HORSHAM DISTRICT COUNCIL CONSULTATION

TO:	Horsham District Council – Planning Dept
LOCATION:	Land at Lower Broadbridge Farm Billingshurst Road Broadbridge Heath Horsham
DESCRIPTION:	Reserved matters application for the erection of 133 dwellings following approval of outline application DC/22/1052 as amended by DC/25/1886, relating to appearance, landscaping, layout and scale
REFERENCE:	DC/26/0592
RECOMMENDATION:	More Information / Modification

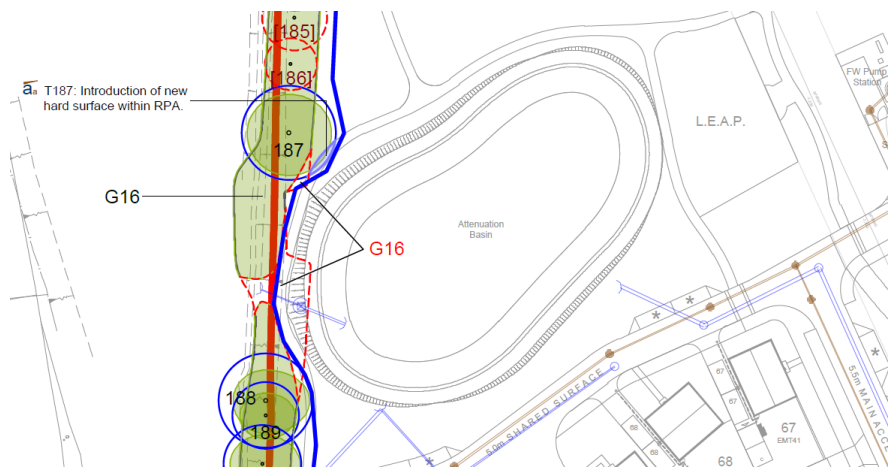
7. Adjustment of the northern attenuation basin further east is requested in order to avoid encroachment of T187 and to limit removal of G16, which is noted to provide partial screening. Altering the location would also provide opportunity to strengthen boundary planting. Please amend.

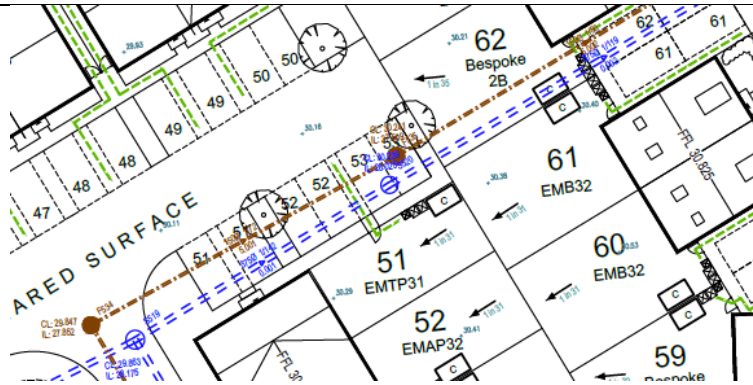
11. A plan demonstrating coordination of the landscape strategy with underground services and existing easement zones is required at this stage to ensure that it can be delivered and that it is not diluted later on in the process.
12. Discrepancies are noted between the Landscape Proposals, Drainage Strategy (DS) and the Tree Protection Plan (TPP), therefore these must be updated to demonstrate consistency, as above.
13. Multiple areas are noted where trees are proposed in proximity to underground services. The inclusion of tree root barriers is noted and welcomed within the Planting Specification, however in order to ensure that proposed trees have a sufficient volume of rooting medium in order to successfully establish and survive, the following is requested:
 - a. The adjustment of service runs to use a single trench. See example below.

- b. Trees within and adjacent to hard landscape to be inclusive of root cells. Details to be included within the Planting Specification and Tree Pit Details.
- c. Relocation of the 6no. trees along the southwestern boundary within the existing sewer easement zone. See below:

GARDEN SEPARATION FENCING -
Garden separation in accordance with developers specification.

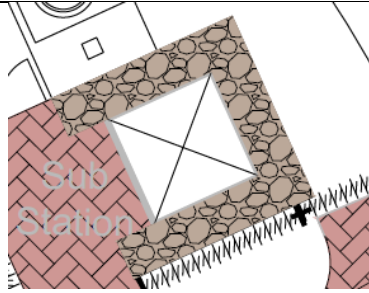
- What is garden separation fencing?
